Millbury Planning Board Site Plan Review Continuance Raymond E. Shaw Elementary School Project

Millbury, MA | Millbury Public Schools
July 20, 2020

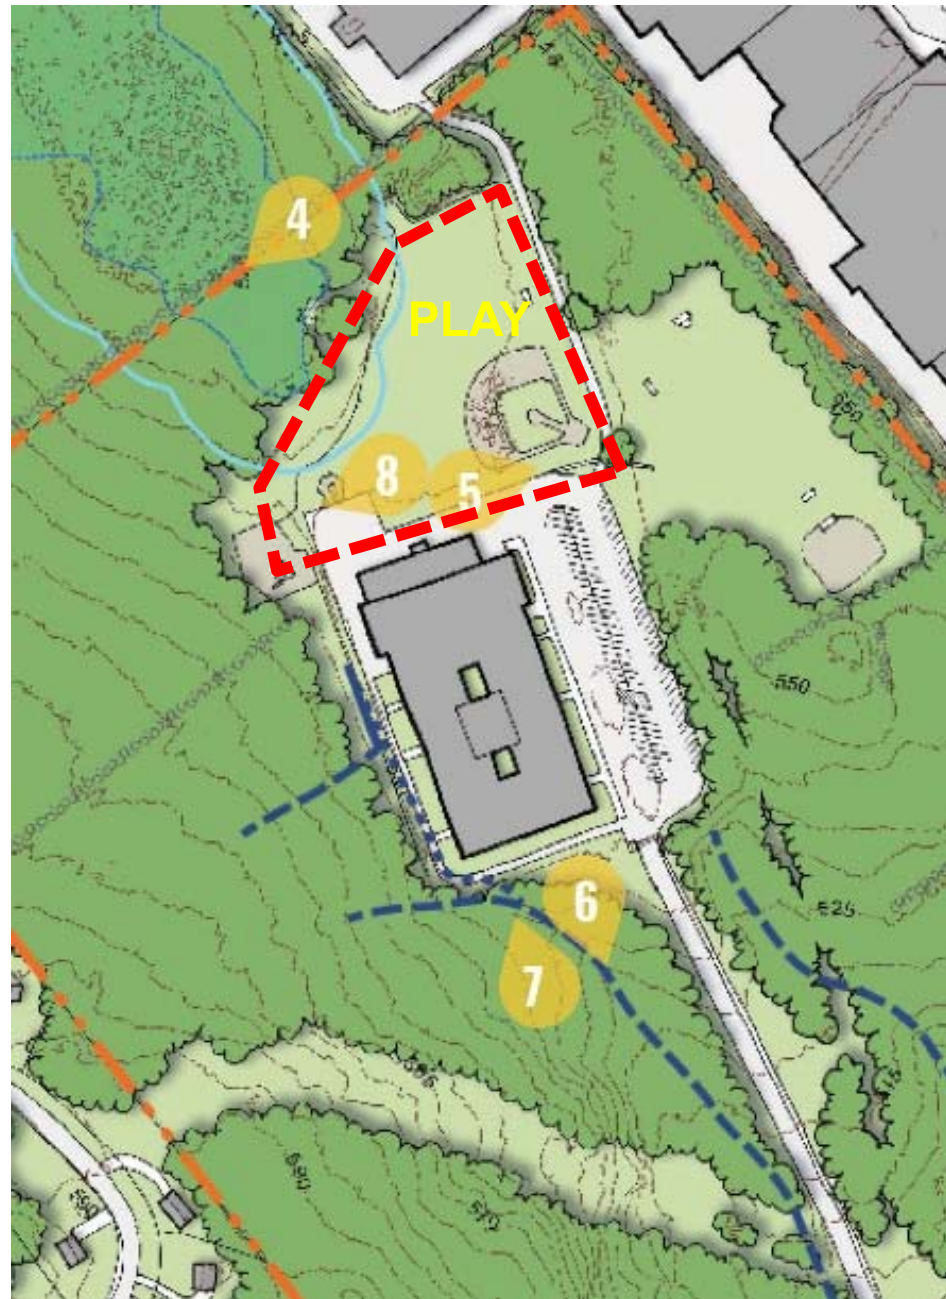
- Are there issues with the proximity to the mall?

Principal Tuccio reports that there have been no issues with the mall being close to the existing school; except people cutting through from Elmwood St to access the Mall.

Existing school play areas are located to the north of the school adjacent to the Mall.

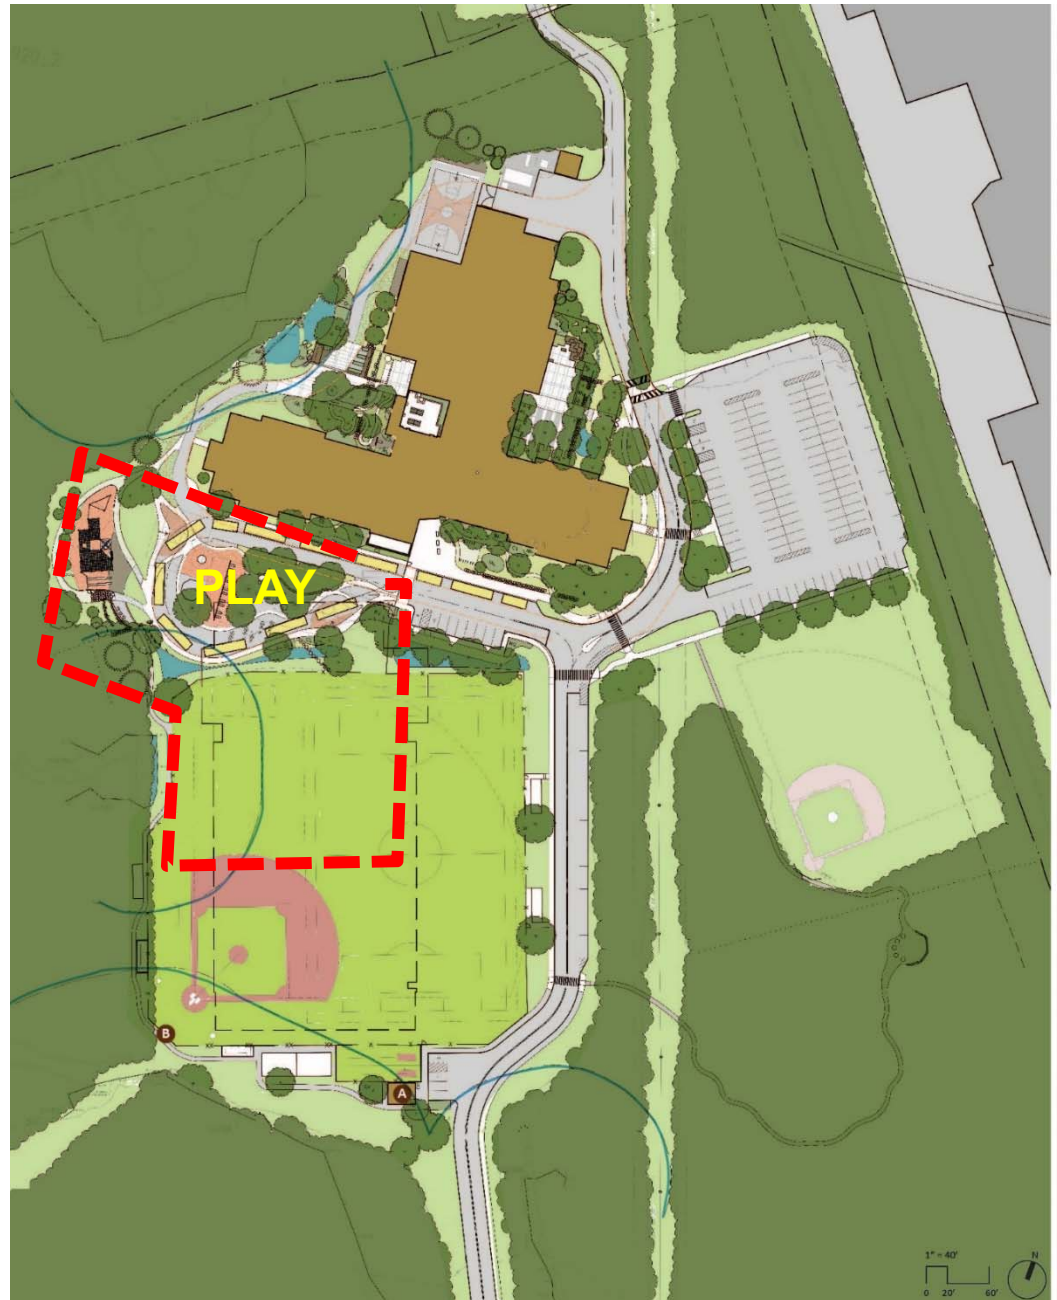
- Are there issues with the proximity to the mall?

The proposed school locates play areas to the south and west side of the new school, further from the mall than the current layout, and protected the buffer of the school building itself.

The proposed school has increased security with a single school hour entrance and surveillance cameras at the exterior

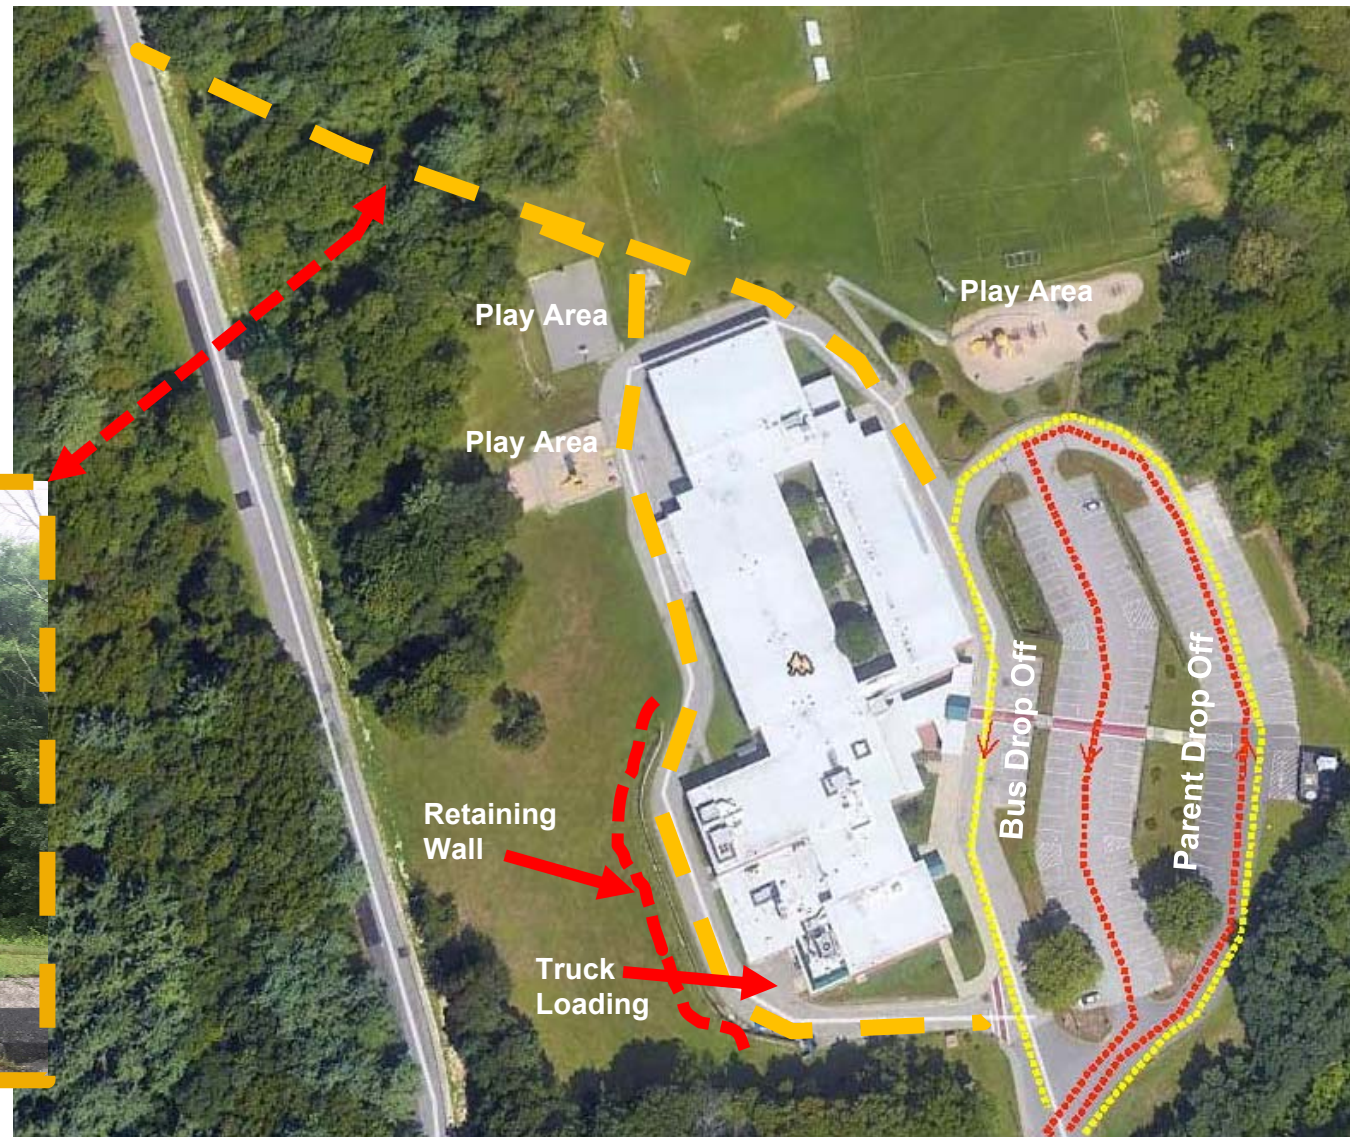
- Is it feasible to combine the Shaw and Elmwood School driveways?

- Most direct location is just north of the Elmwood school where the sewer line runs.
- Security and safety concerns pushing Shaw traffic through Elmwood Site

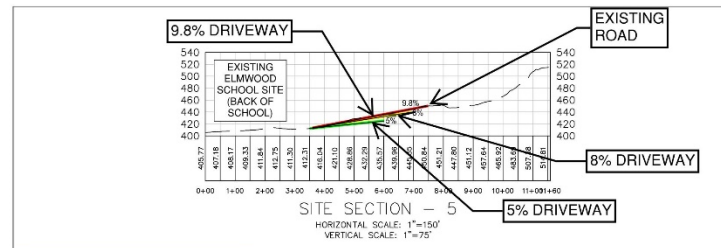
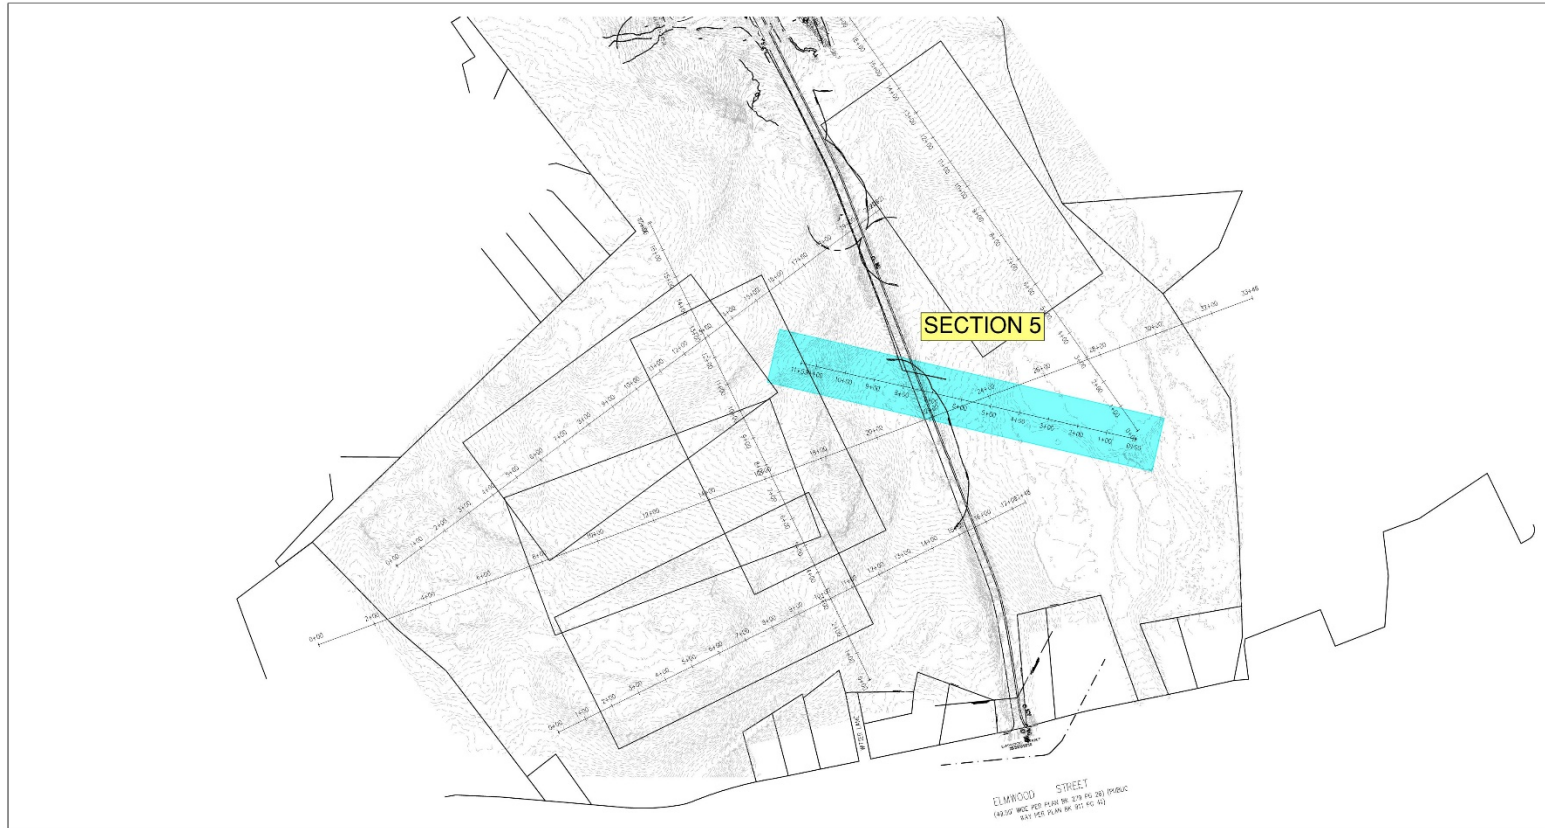
- Is it feasible to combine the Shaw and Elmwood School driveways

POTENTIAL LOCATION FOR ACCESS TO ELMWOOD SCHOOL - UTILITIES AND WETLANDS NOT REVIEWED. ACCES AT BACK OF ELMWOOD

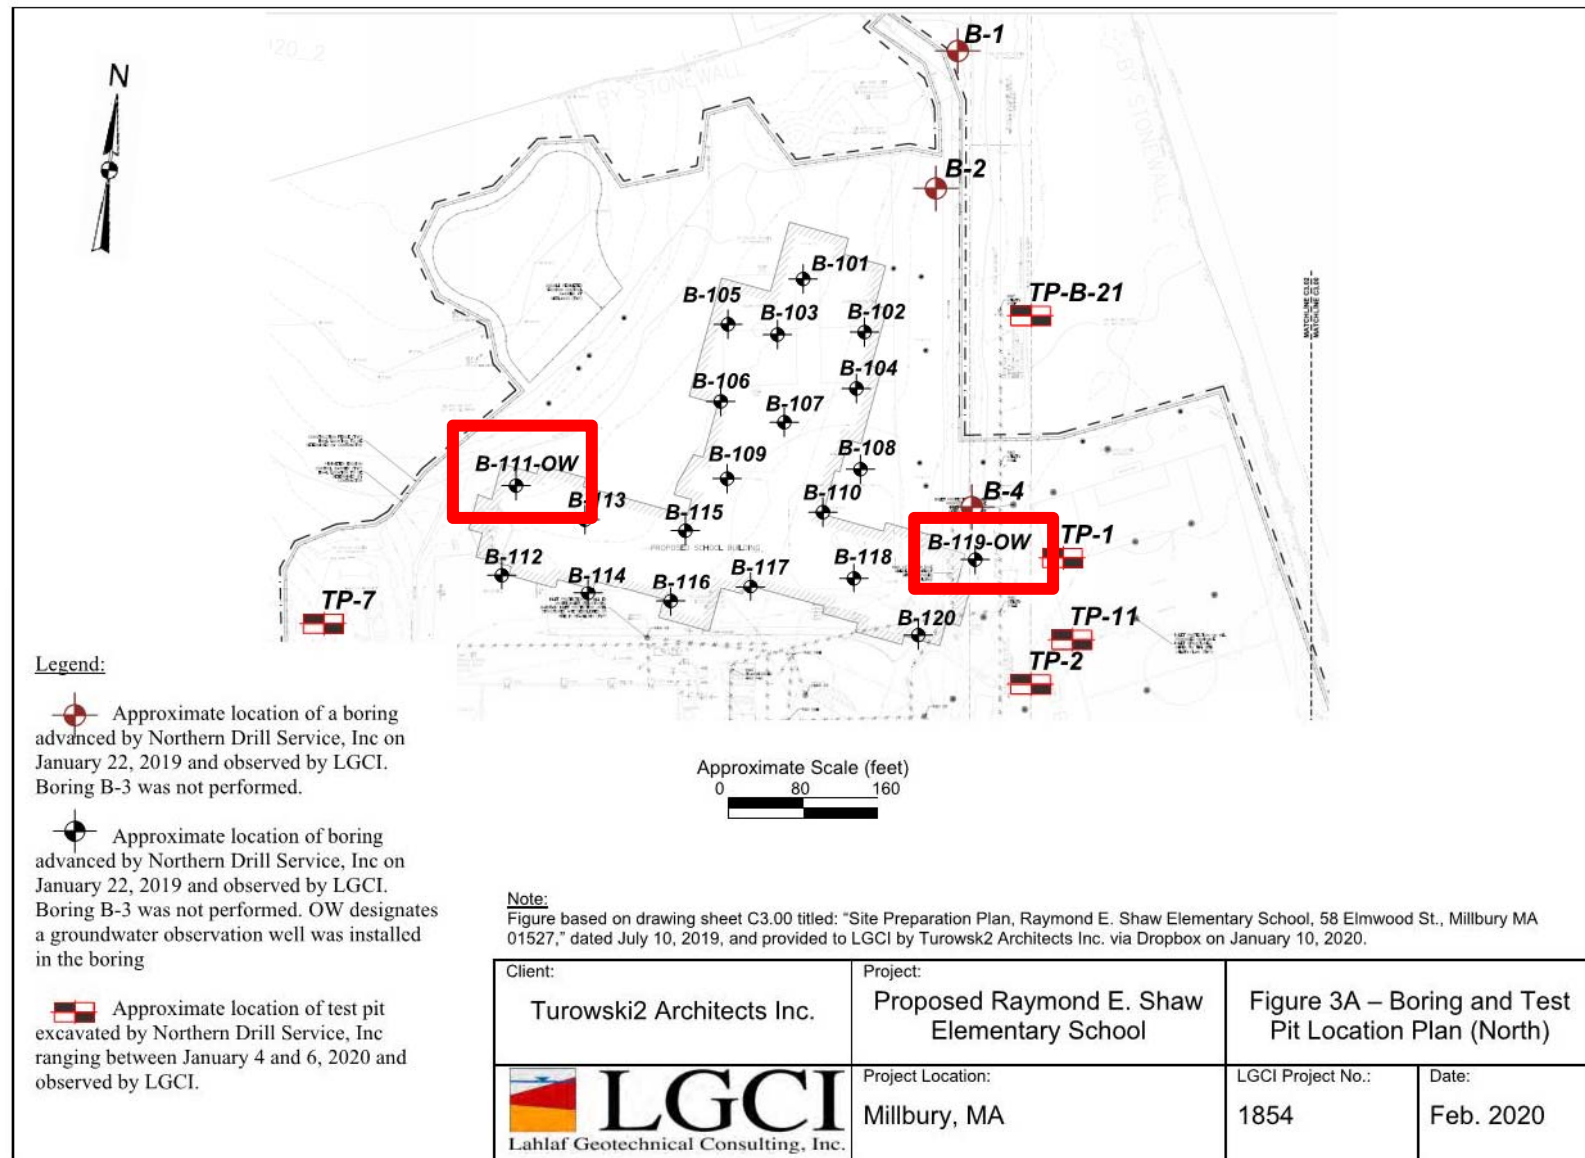
- Where were the borings and test pits done? 2 Observation Wells

14 Test Pits

21 Borings

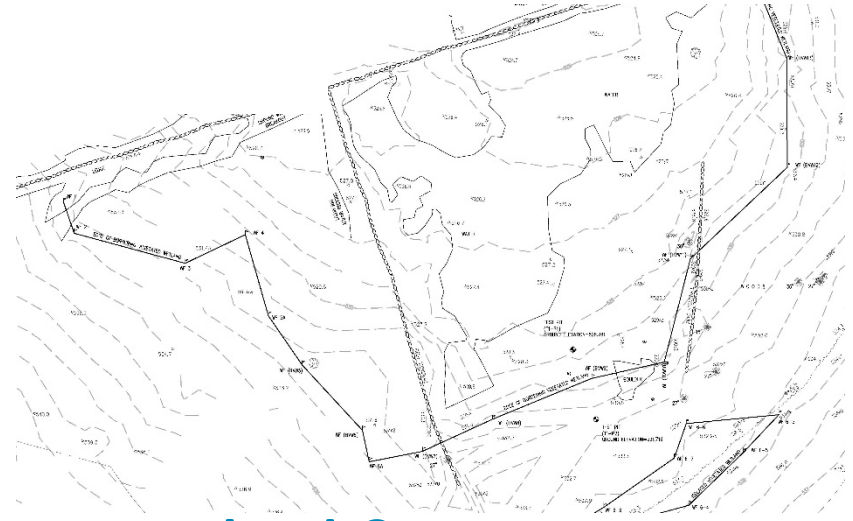
- What are the elevations of the northern wetlands?

Wetland Elevation = 528'+/-

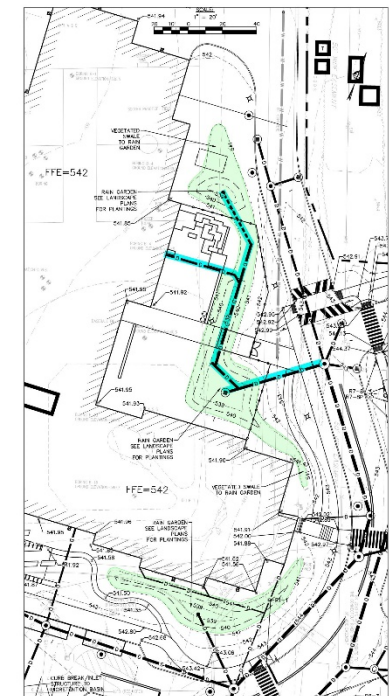
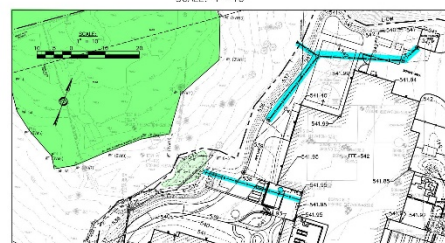
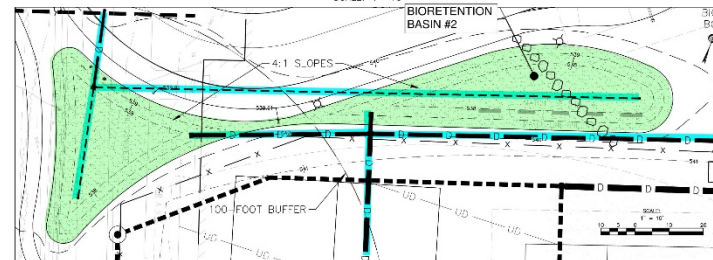
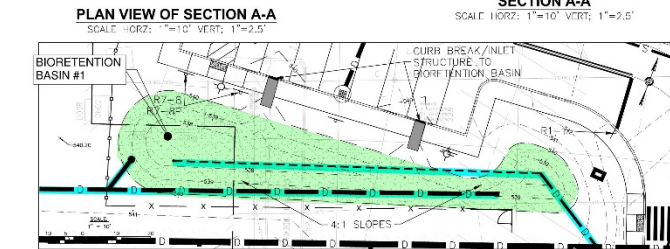
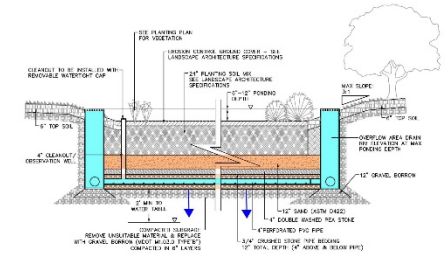
• How is the overflow of Basins 1 & 2 being handled?

If the basins north of the sports field are nearing capacity, there are structures just below the top that will prevent an overflow by directing the water to a discharge south of the sports field via underground piping.

6 UNDER-SLAB DRAINAGE DETAIL
P0.01 (TRENCHES AT 15 TO 20-FOOT SPACING TO CLEAR FOOTINGS)
N.T.S.

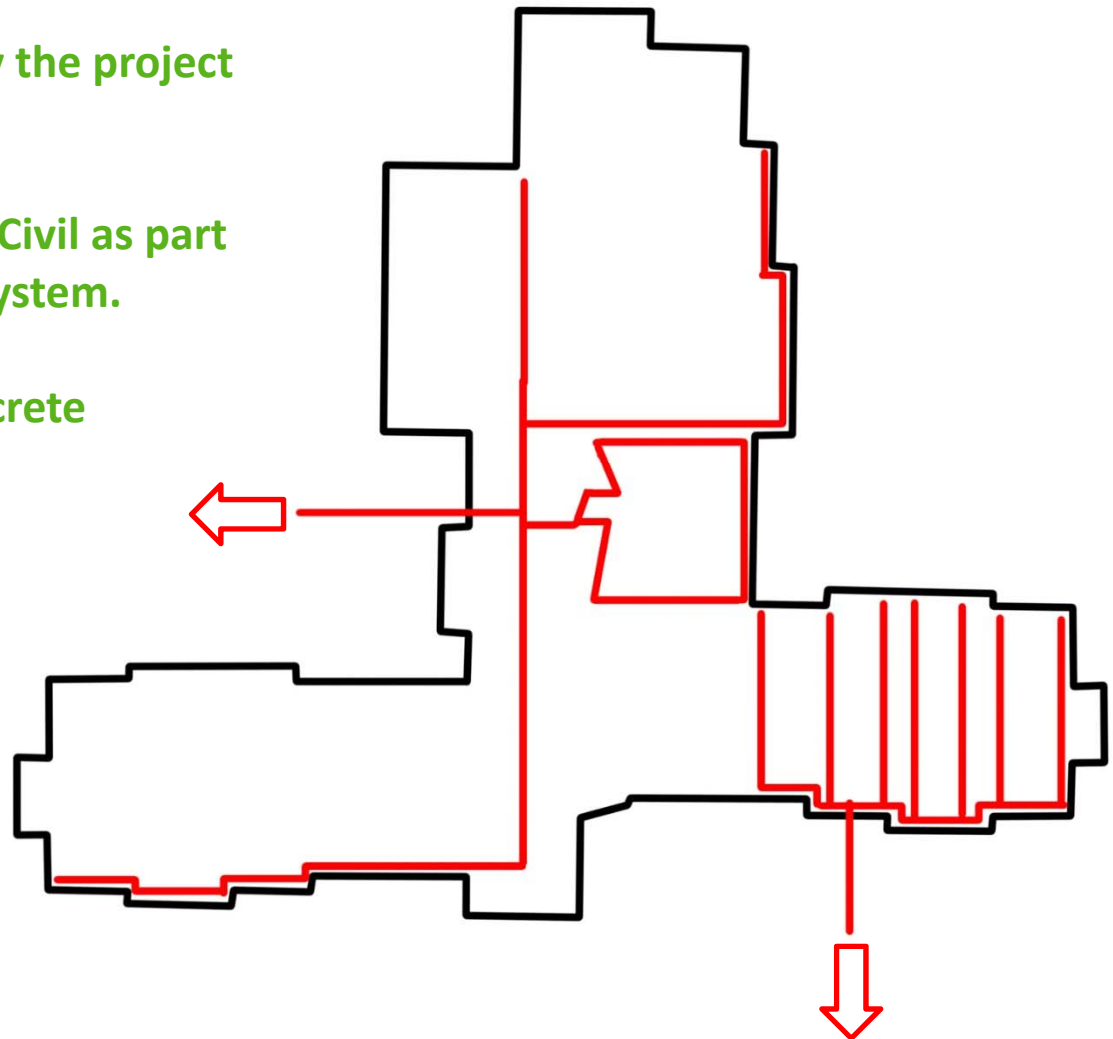
- How is the under-slab drainage system designed? Where does it flow?

Layout and detail was provided by the project geotechnical engineer.

Outlets to the West and South by Civil as part of the stormwater management system.

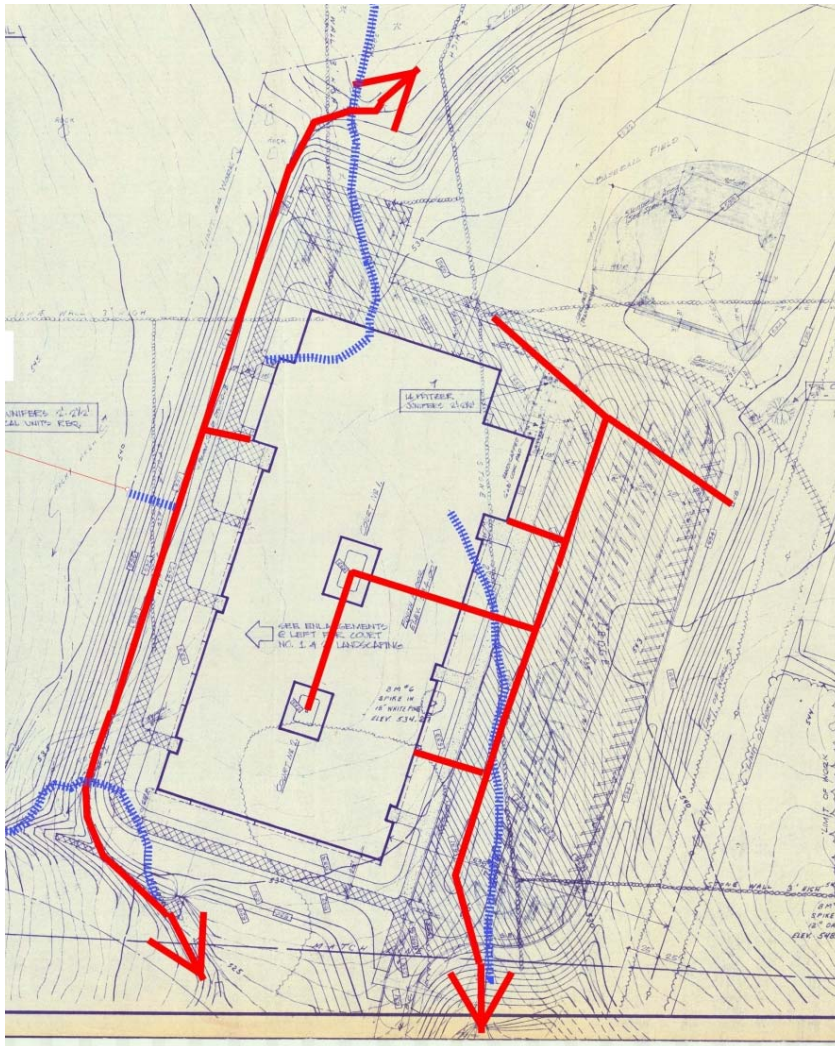
- The water management for the existing building is inadequate. How is the proposed design going to keep the building and recreational sections of the site dry?

The existing building was located over a seasonal brook. There is no under-slab drainage system. The existing foundation had crystalline waterproofing admixture that may have trapped the water within the building footprint worsening the issue.

New building has a layered ground & stormwater management approach that is consistent with highest standards of engineering practice.
